From: Hoellman, Jordan
Sent: Wednesday, October 10, 2018 3:35 PM
To: Vogtle PEmails <Vogle.PEmails@nrc.gov>
Subject: Slides for 10/11/18 Public Meeting on Column Line 1 Wall (LAR 18-026)

Forwarding these slides for discussion at the October 11, 2018, public meeting regarding LAR 18-026, Column Line 1 Wall Reinforcement Area Change.

LAR-18-026: Column Line 1 Wall Reinforcement Area Change

Figure 3H.5-3
[Typical Reinforcement in Wall on Column Line 1]*

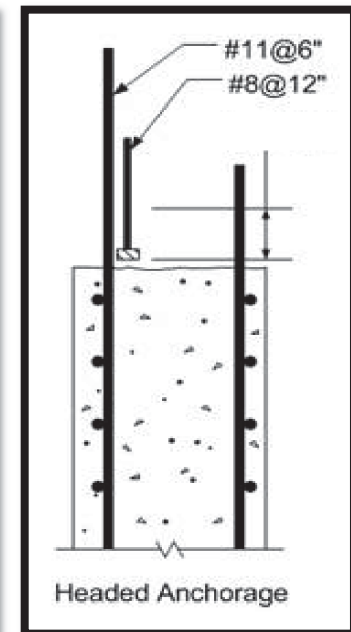
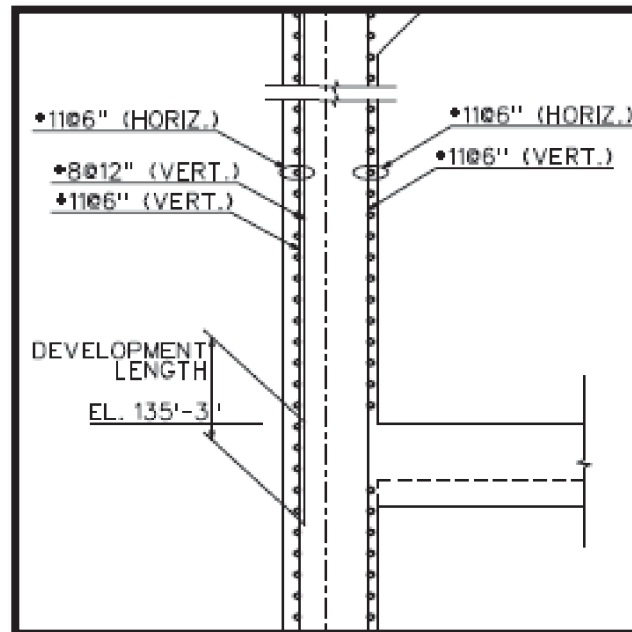
Column Line 1 Wall (Auxiliary Building @ El. 135'-3")

- Identified on October 1st that #8's at 12" were not placed below 135'-3" to allow for development.
- Proposed change to rebar configuration.
 - Development length of #8's @ 12" to begin at 135'-3" using T-heads.
 - Impacts provided area of reinforcement from 135'-3" through development length.
- Plan to submit PAR concurrently.
